TC1775

32-Bit Single-Chip Microcontroller

TC1775 Documentation Addendum

Revision History: 2004-11

DMU_CON
DMU Control Register **Reset Value: 0000 0000_H**

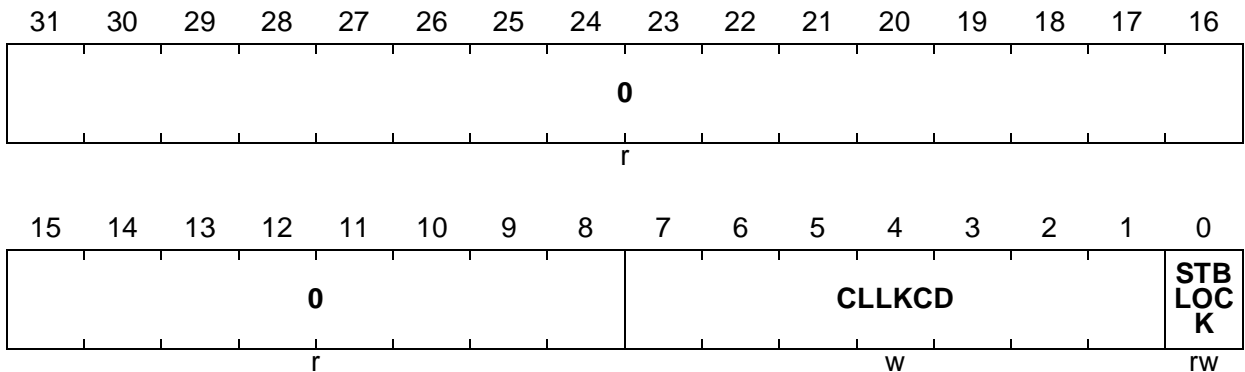
The description of register DMU_CON must be corrected in the following way:

Field	Bits	Type	Description
STBLOCK ¹⁾	0	rw	Lock Standby Data Memory Bit can be set by writing a 1 to it (in supervisor mode only). Bit can only be reset (in supervisor mode only) by writing a 0 to it together with the appropriate clear lock code. 0 Normal operation of standby data memory 1 Standby data memory is locked. No read or write access of/to standby SRAM is possible. The state of STBLOCK after power-on reset is undefined. A hardware or software reset does not effect this bit.
CLKCD	[7:1]	w	Clear Lock Code This bit field has to be written with 65 _H together with STBLOCK = 0 to reset the lock of the standby RAM.
0	[31:8]	r	Reserved ; read as 0; should be written with 0.

Figure 10-2 Example Configuration of a Data Protection Register Set

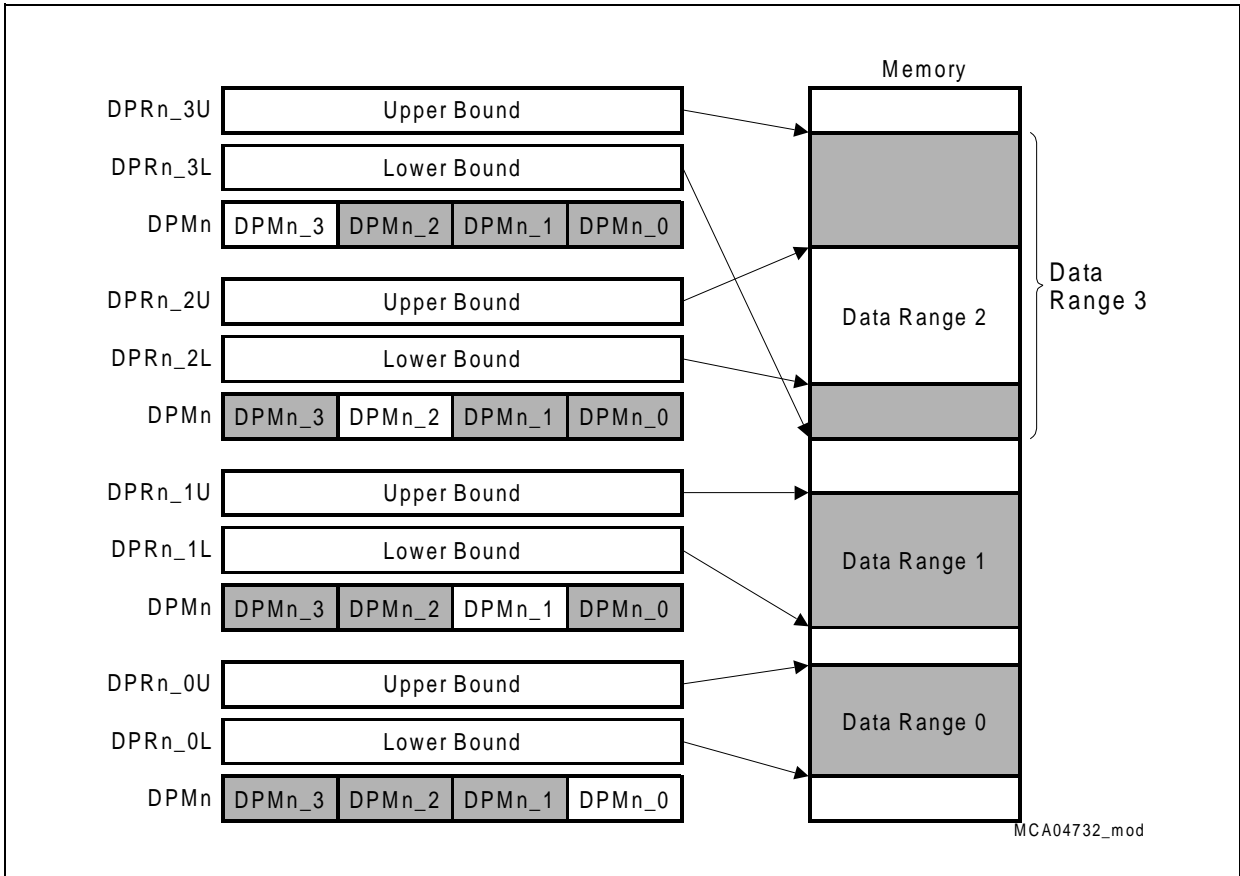
The Data Range numbering in **Figure 10-2** is not correct. The figure must be updated in the following way:

Figure 12-6 Basic Read Access Timing in Demultiplexed Mode

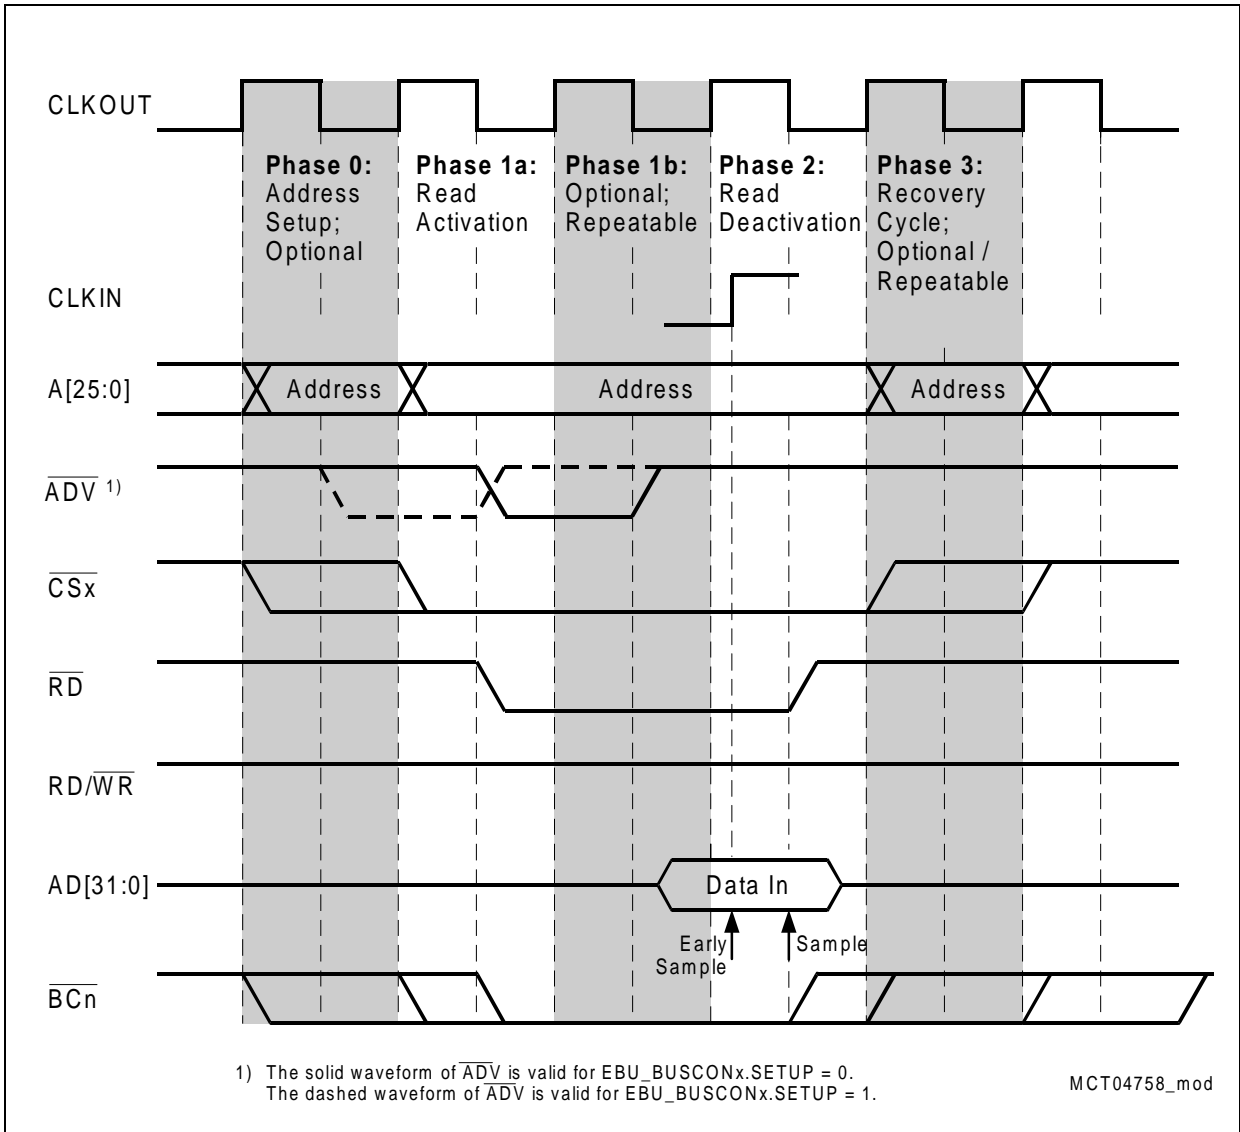
The TC1775 provides an additional demultiplexed read timing feature called “Early Sample”. This feature is shown in the corrected **Figure 12-6** and controlled via bit 26 (called ES for “Early Read Sample Select”) in register EBU_BUSCONx. EBU_BUSCONx.ES must be added as described on **Page 12**).

Due to this new feature, the paragraph starting with “Phase 2: ...” on page 12-21 must be replaced by the following description:

Figure 12-6 and **Figure 12-7** are also corrected concerning signal \overline{ADV} . As shown in these two figures, the \overline{ADV} timing depends on the setting of bit `EBU_BUSCONx.SETUP`.

- “Phase 2: This cycle is always part of a read access. Please note that the read signal is deactivated (high) on the falling edge of CLKOUT. The data input is sampled and latched with this clock edge (EBU_BUSCONx.ES = 0) or with the rising edge of CLKIN when early sample is enabled with EBU_BUSCONx.ES = 1.”

Figure 12-16 EBU Boot Process after Reset

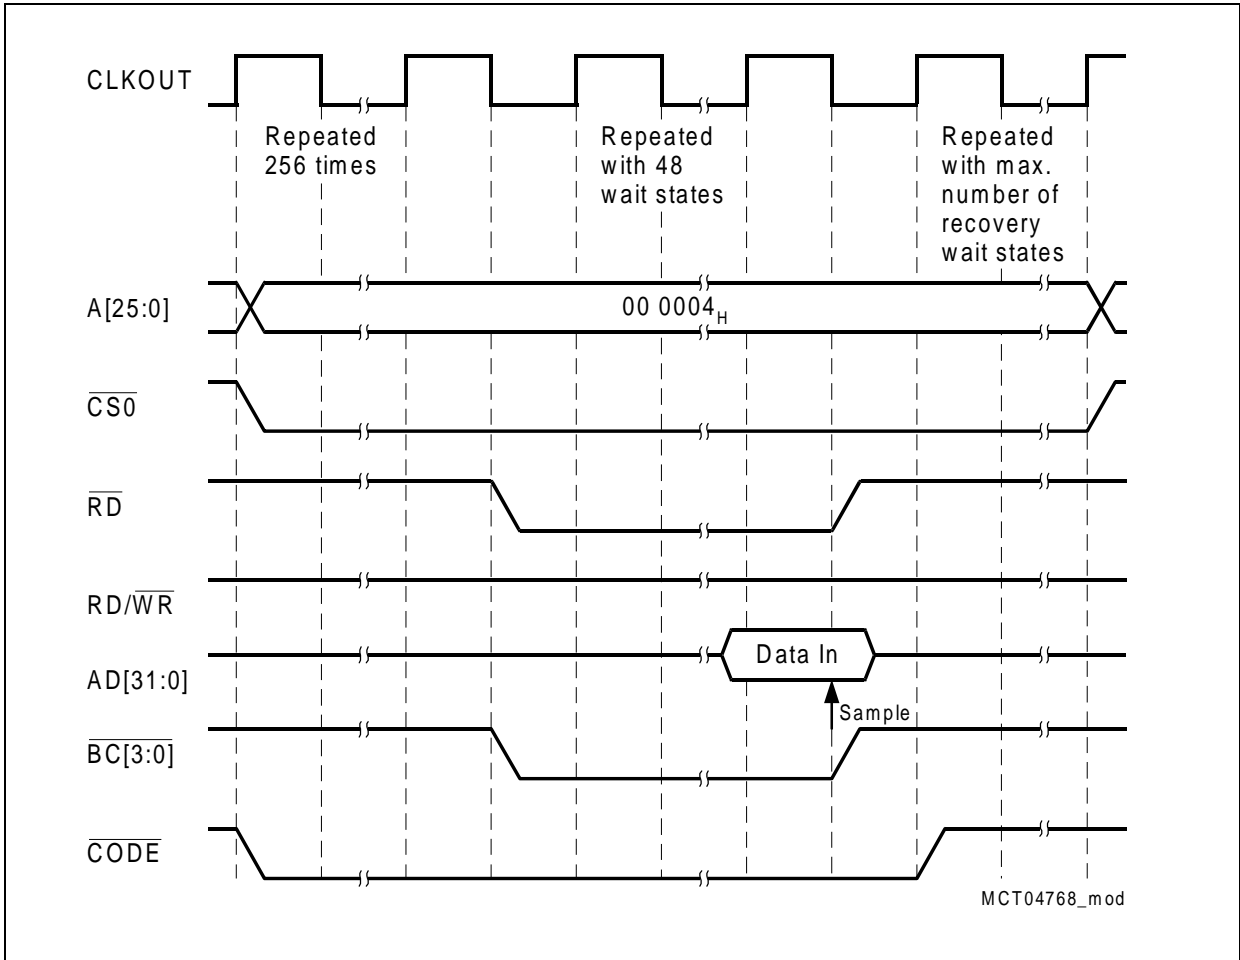
Page 12-44, Update of Figure 12-16

Figure 12-16 should be update with the following drawing:

Figure 31 Approximated Maximum Accumulated PLL Jitter for Typical System Clock Frequencies f_{SYS}

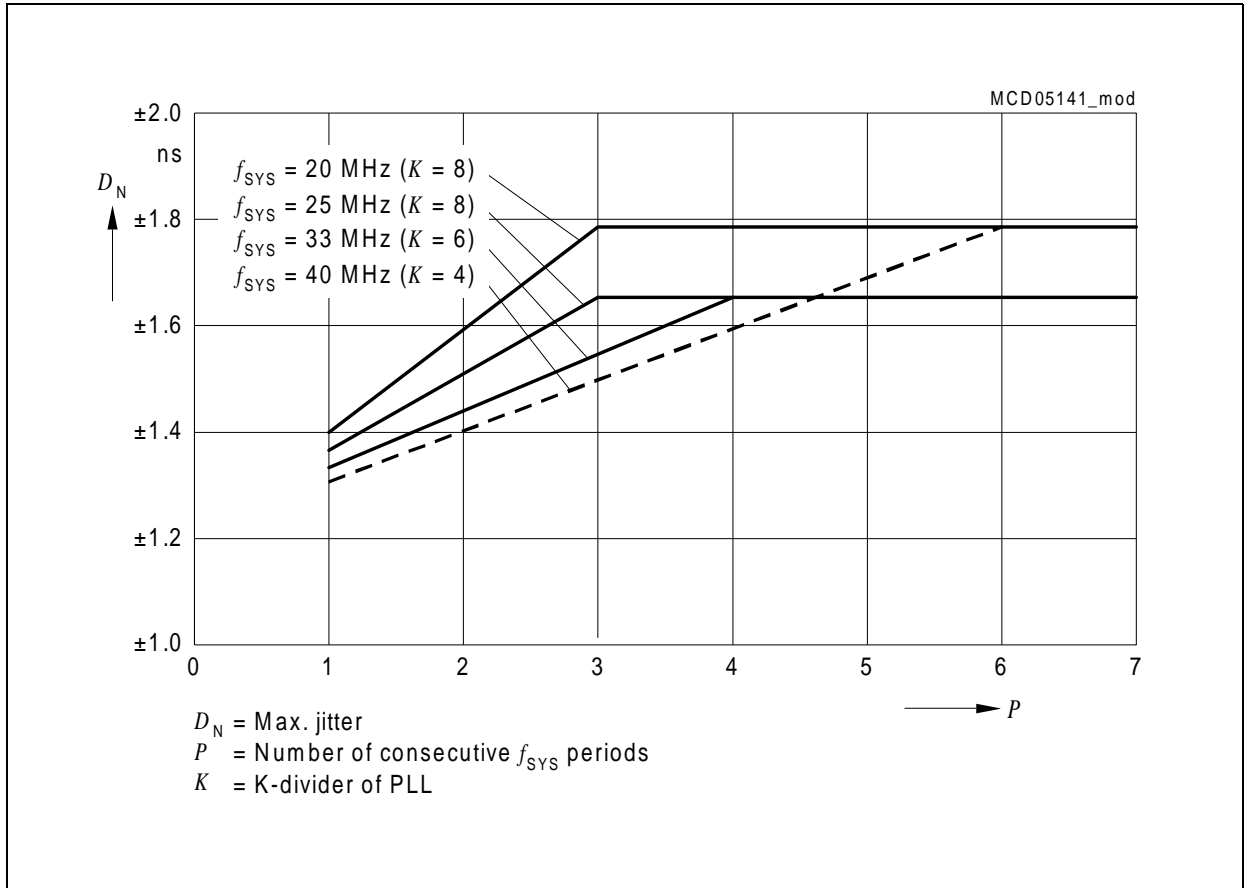
Caused by the correction of Figure 31 on page 83, the last paragraph must be updated as follows: “Figure 31 gives an example for typical jitter curves with $K = 4$ @40 MHz, $K = 6$ @33 MHz, and $K = 8$ @20/25 MHz.”

Figure 31 must be corrected as shown below.
